# Value Engineering Study Report

*Project No. BRSTO-0998-00(001)*

*SR 324 Gravel Springs Road @ I-85*

*Gwinnett County*

ALTERNATIVE NO.:  
**RD-1**

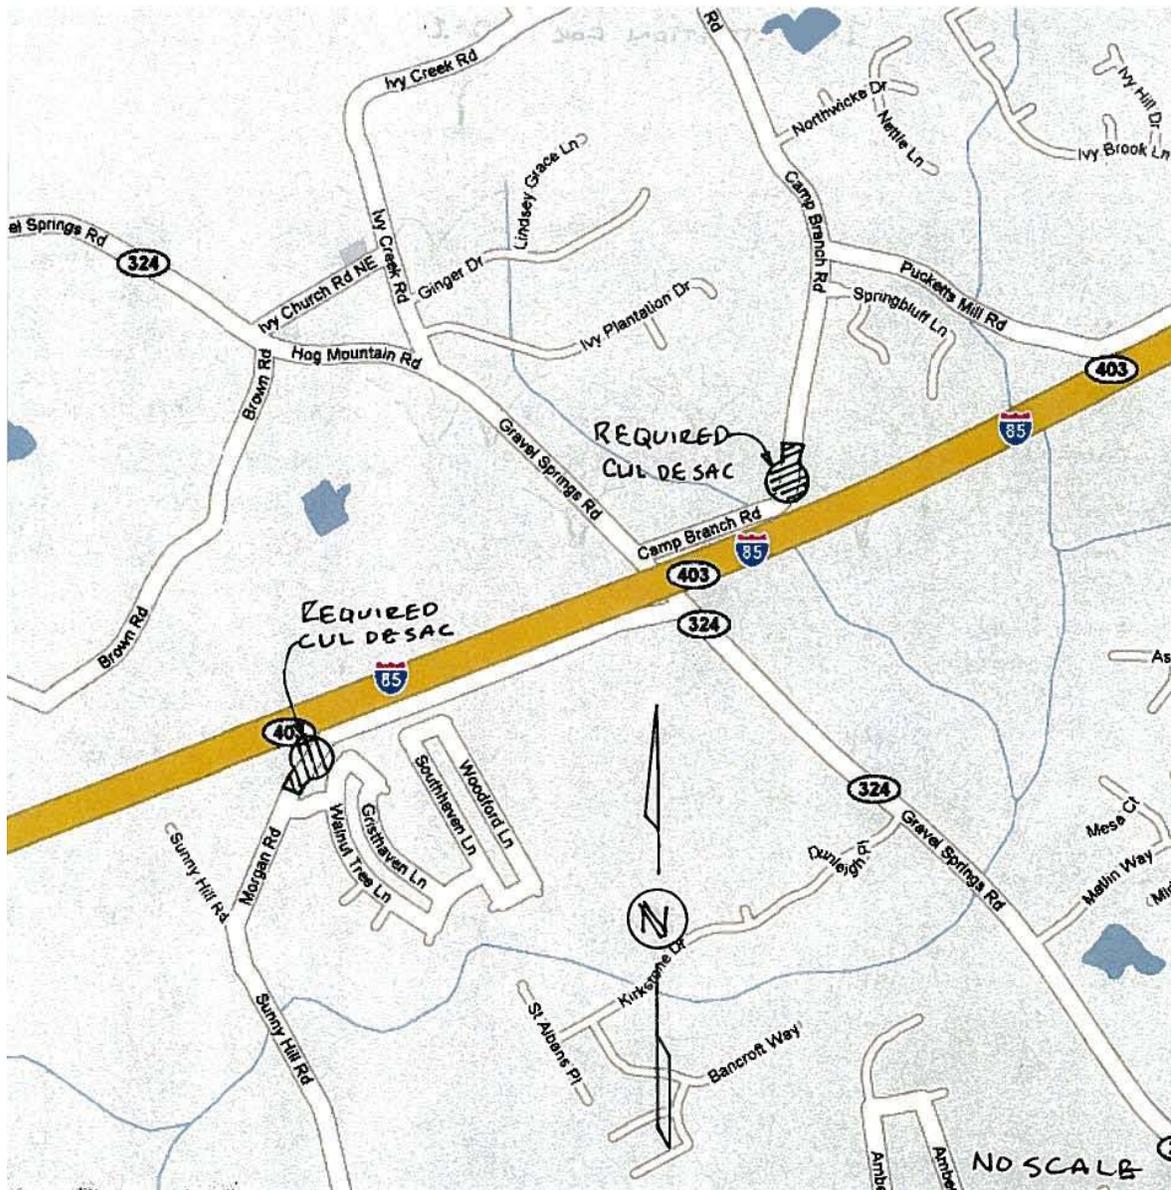
The original design relocates the intersections of Morgan and Camp Branch Roads approximately 1200' east and west of their current respective locations.

The alternative would propose constructing Cul-de-sacs on Camp Branch Road and Morgan Road where they become parallel to I-85.

The existing road network provides sufficient access for the areas serviced by the County roads. An additional option could be to provide a right-in / right-out connection to the future collector distributor roads on I-85.

ALTERNATIVE NO.:  
**RD-4**

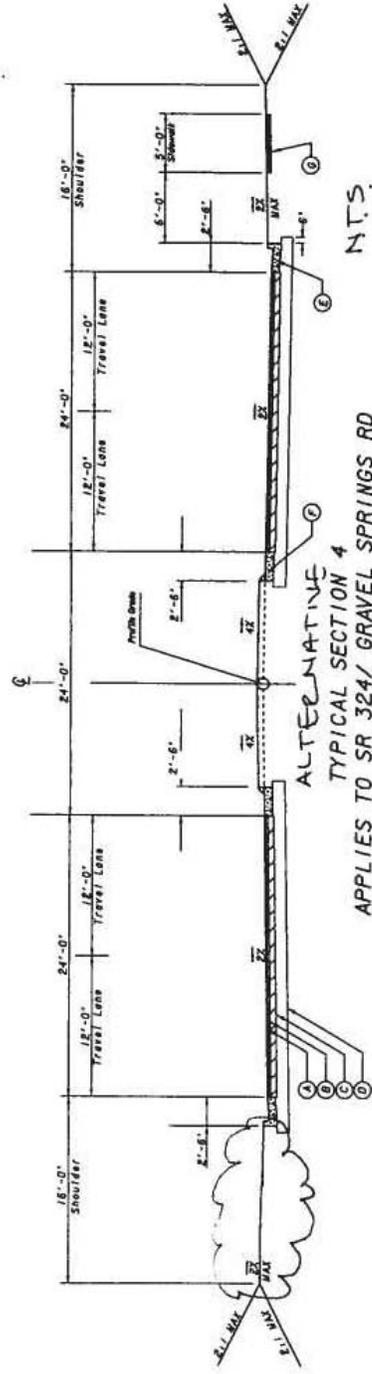
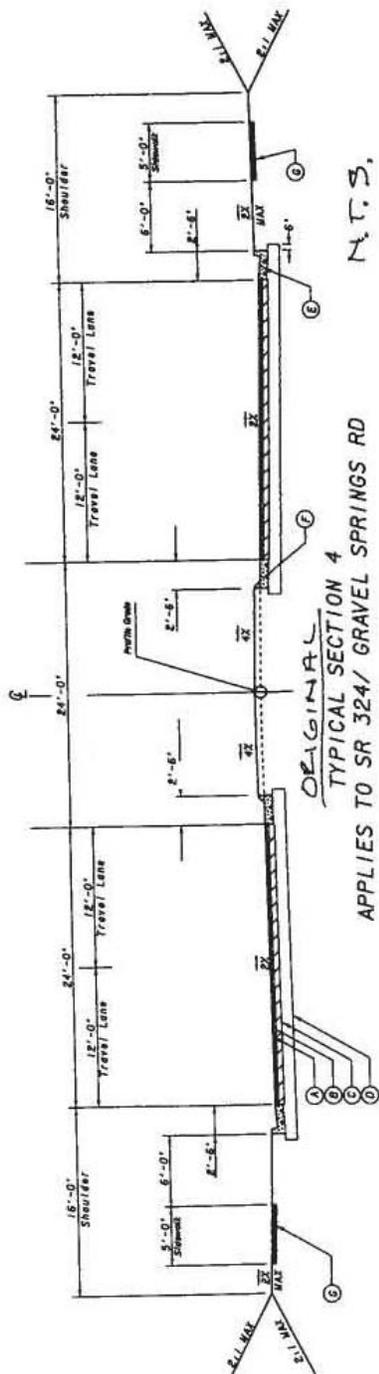
The original design calls for sidewalks on the north side and south side of SR 324.

The alternative would provide for sidewalks on the south side of the roadway only.

The existing design does not provide a sidewalk on the north side of SR 324 from Sta. 132+00 to 136+79 due to limitations imposed by the historic tree preservation condition and renders a discontinuity for pedestrian access. The best idea would be to eliminate the sidewalk completely on the north side of SR 324. This would result in a cost savings on approximately 4100 linear feet of sidewalk construction.

ALTERNATIVE NO.:  
**RD-5**

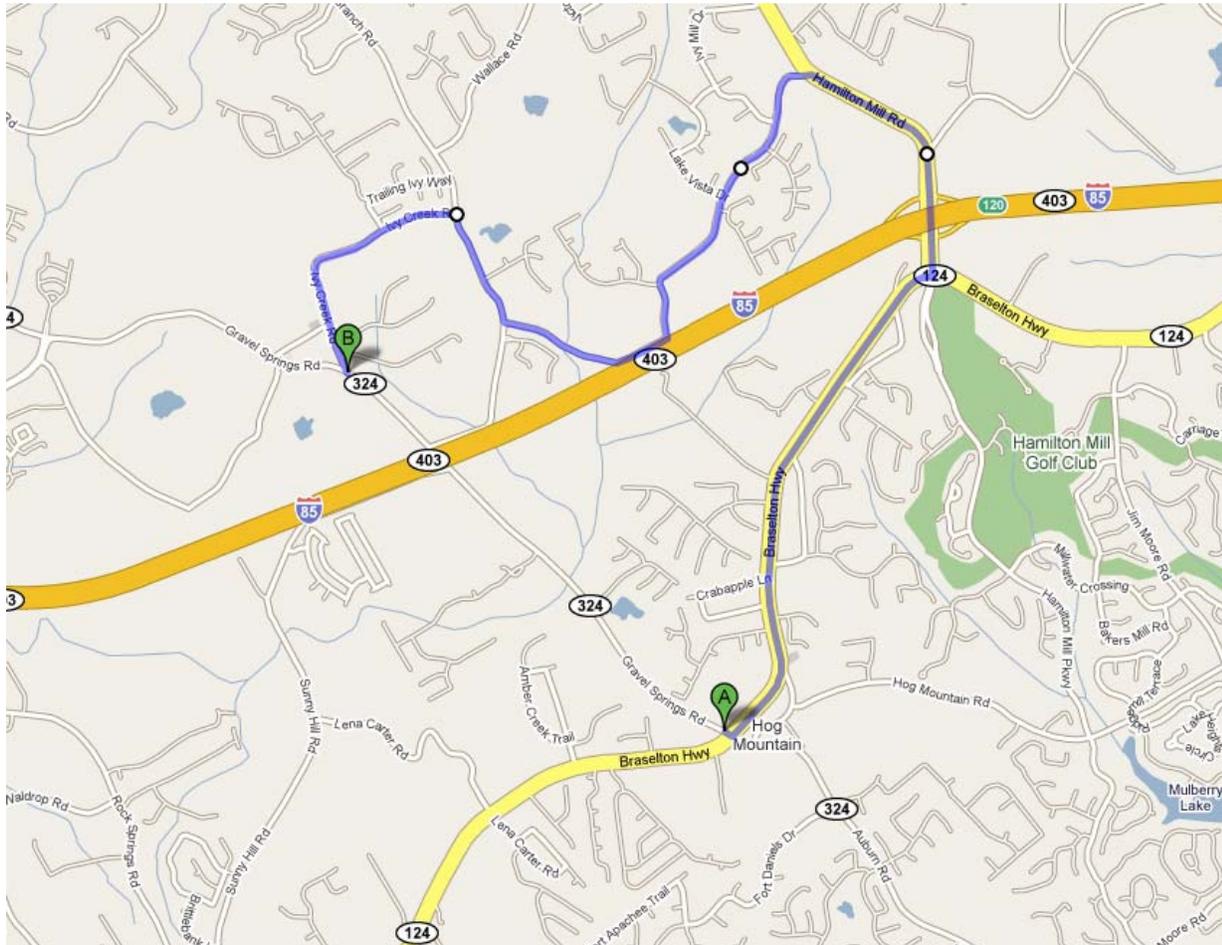
The alternative design proposed is to close the bridge, provide a detour and complete the bridge construction in one phase without the need for shoring.

ALTERNATIVE NO.:  
**RD-11**

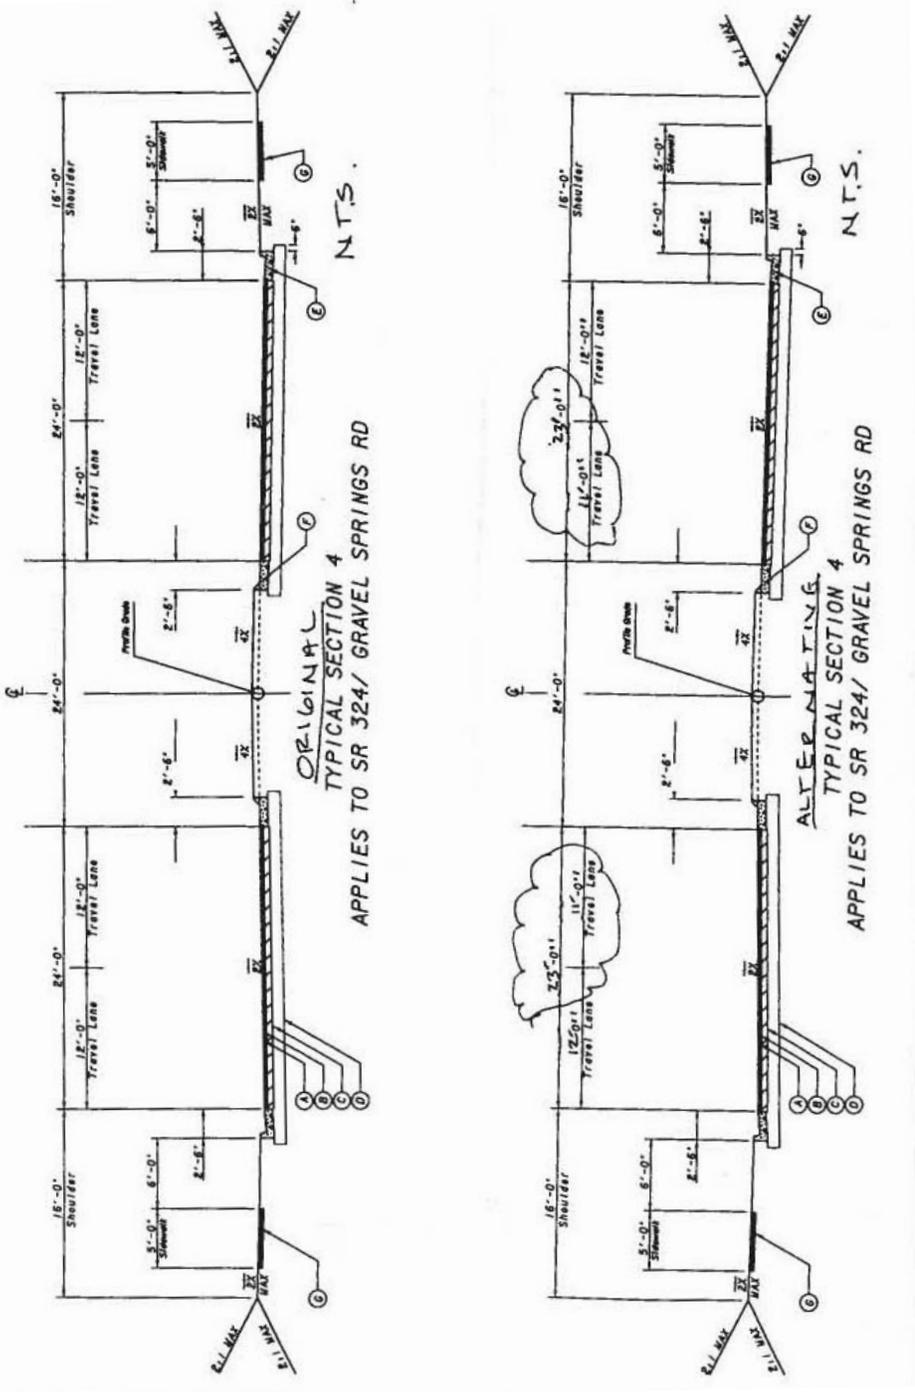
PROJECT:	<b>Georgia Department of Transportation BRST0-0998-00(001) – P.I. No.: 142285 SR 324 Gravel Springs Rd. @ I-85 Gwinnett County</b>	ALTERNATIVE NO.:	<b>RD- 11</b>
DESCRIPTIO	<b>Use 11’ inside lanes, 11’ turn lanes, and 12’ outside lanes for typical section on SR 324</b>	SHEET NO.:	<b>1 of 4</b>

DESCRIPTION: Provide crosswalks where needed

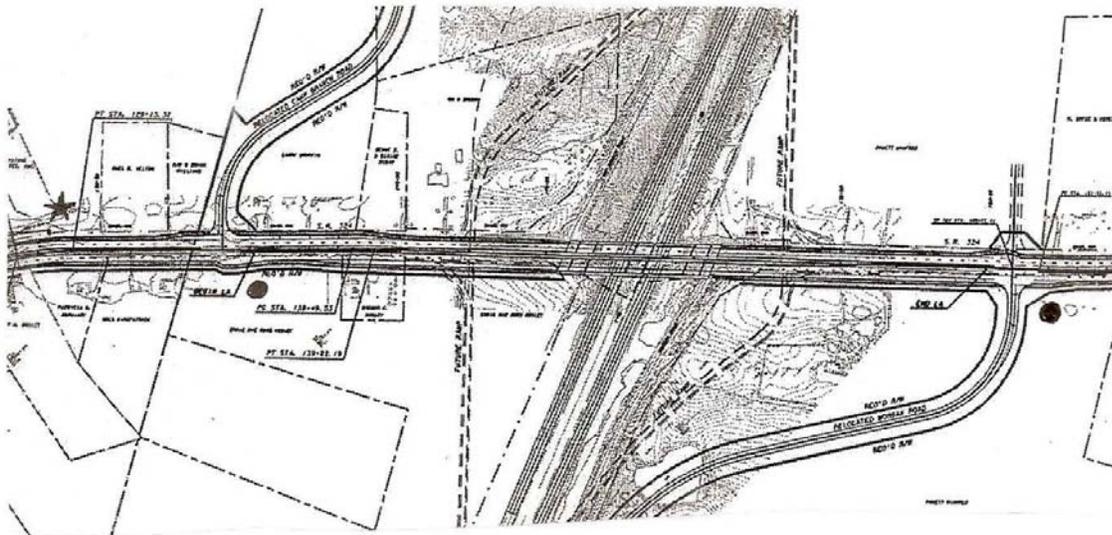
The alternative would provide SR 324 crosswalks in three places – at the termination of the sidewalk near the specimen trees at Camp Branch Road, at Camp Branch Road and at Morgan Road (see enclosed sketch).

There is no formalized provision for pedestrians crossing the SR 324 roadway, in spite of the fact that sidewalks are to be constructed on both sides of the new roadway. Crosswalks should be striped and warning signs posted to help protect the few pedestrians that are likely to use the crosswalk. The attached sketch illustrates the three problem areas and identifies the crosswalk locations that might be considered. This would obviously work better if these locations were signalized. Signalization would not be likely at the location identified with a star. Consideration might be given to extending the sidewalk in this location by running it behind the protected trees. This appears to be the only location for the sidewalk since the tree-protecting guardrails are placed directly behind the curb.

ALTERNATIVE NO.:  
**RD-15**

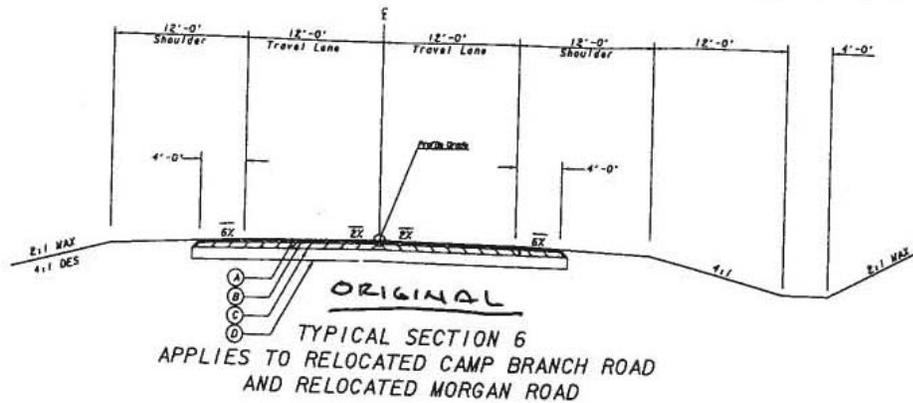
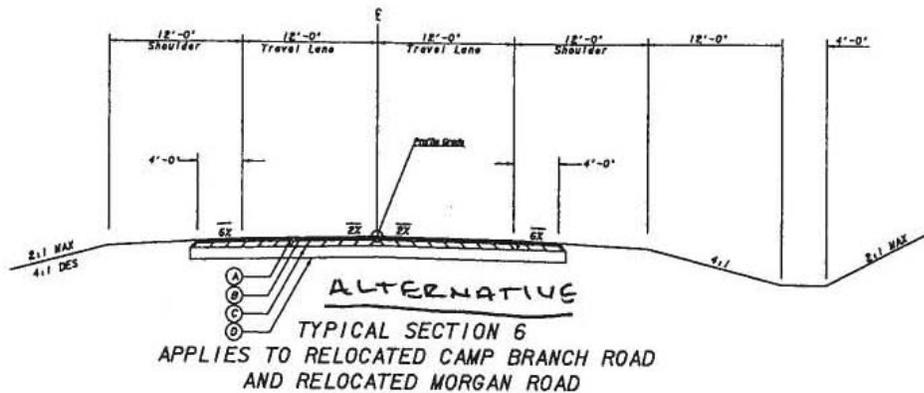
<b>PROJECT:</b>	<b>Georgia Department of Transportation</b> <b>BRST0-0998-00(001)- P.I. No. 142285</b> <b>SR 324 Gravel Springs Rd. @ I-85</b> <b>Gwinnett County</b>	<b>ALTERNATIVE NO.:</b>  <b>RD-15</b>
<b>DESCRIPTION:</b>	<b>Reduce pavement thickness for county roads</b>	<b>SHEET NO.: 4 of 4</b>

ALTERNATIVE NO.:  
**BR-1**

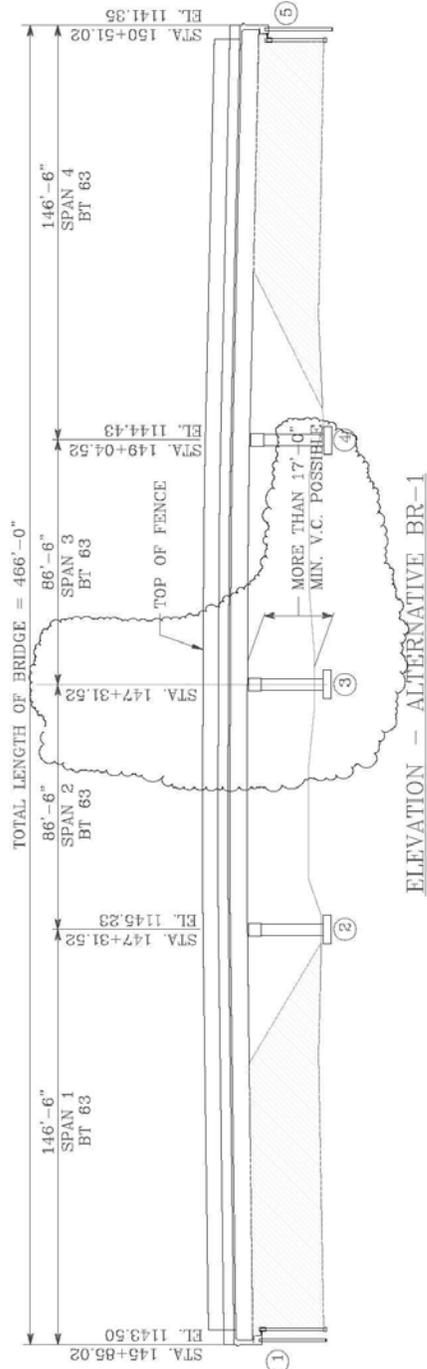
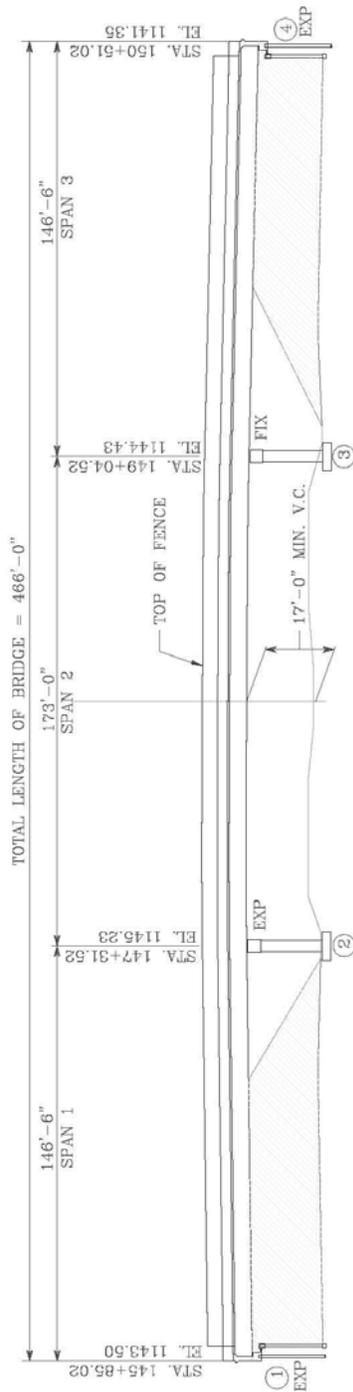
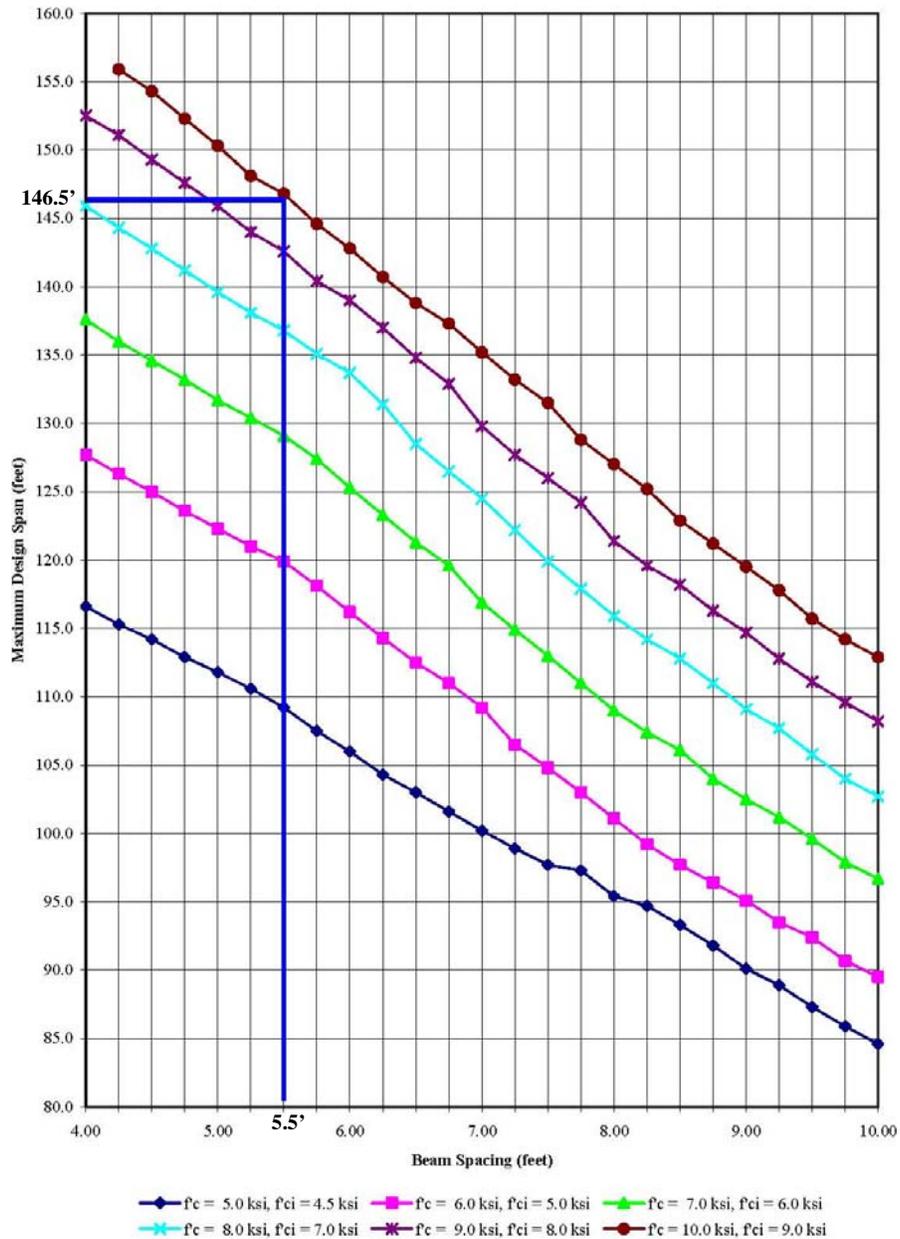
The original design calls for a skewed, 466' long, 3 span bridge with MSE walled abutments. The end spans are 146.5' and the intermediate span is 173.0' long. From final bridge plans made available to the VE Team, it appears that the superstructure comprises a concrete deck on steel plate girders, approximately 75" deep, made continuous over the 3 spans. The bridge crosses the future (conceptual) widened sections of I-85. The out-to-out width of the bridge is 102'-5" to accommodate 6' raised sidewalks on each side, a 32' median (6' raised) and two 12' travel lanes in each direction. It is proposed that the raised median be removed in the future to accommodate two turn lanes when this crossing is converted to a TUD Interchange. The intermediate bents are made up of concrete caps and columns and founded on pile caps supported by Steel H Piles.

The alternative suggests placing an intermediate bent in the future I-85 median and reconfiguring the spans to provide 4 spans. BT-63 girders with 10 ksi strength concrete, spaced approximately 5.5', could be used in-lieu of the steel plate girders for the revised span configuration. The deck section in the alternative will be the same as in the current design.

ALTERNATIVE NO.:  
**BR-2**

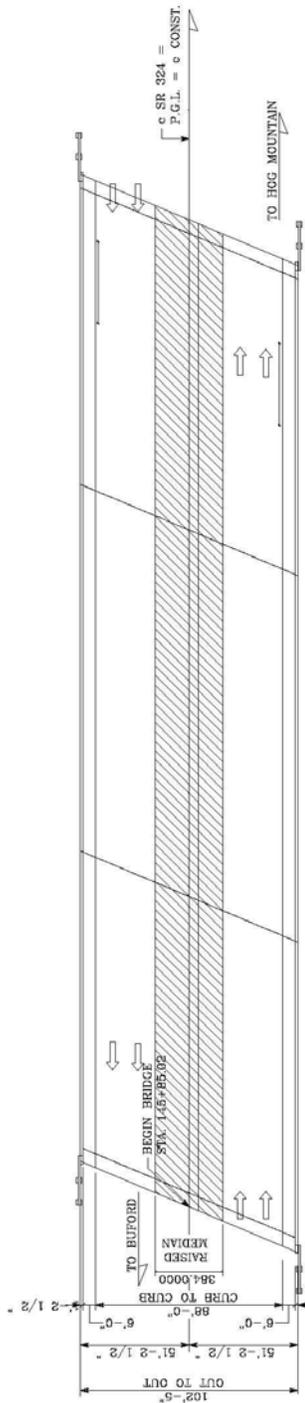
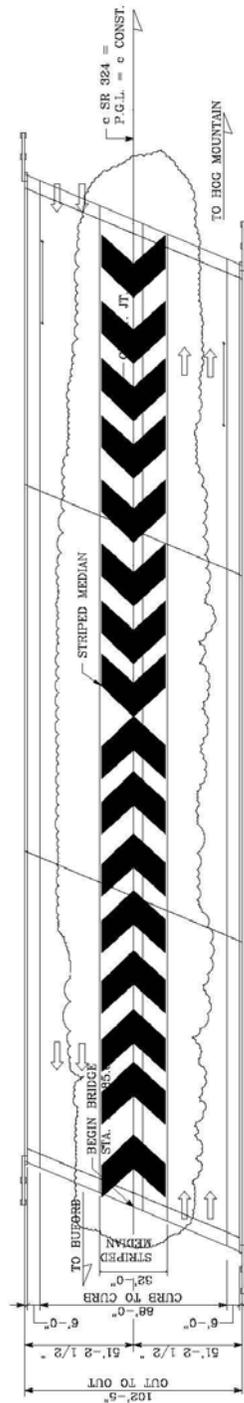
The original design calls for a skewed, 466' long, 3 span bridge with MSE walled abutments. The end spans are 146.5' and the intermediate span is 173.0' long. From final bridge plans made available to the VE Team, it appears that the superstructure comprises of a concrete deck on steel plate girders, approximately 75" deep, made continuous over the 3 spans. The bridge crosses the future (conceptual) widened sections of I-85. The out-to-out width of the bridge is 102'-5" to accommodate 6' raised sidewalks on each side, a 32' median (6' raised) and two 12' travel lanes in each direction. It is proposed that the raised median be removed in the future to accommodate two turn lanes when this crossing is converted to a TUD Interchange. The intermediate bents are made up of concrete caps and columns and founded on pile caps supported by Steel H Piles.

- Potential savings in construction costs and removal costs for proposed future interchange modifications
- Reduced dead loads on the bridge girders
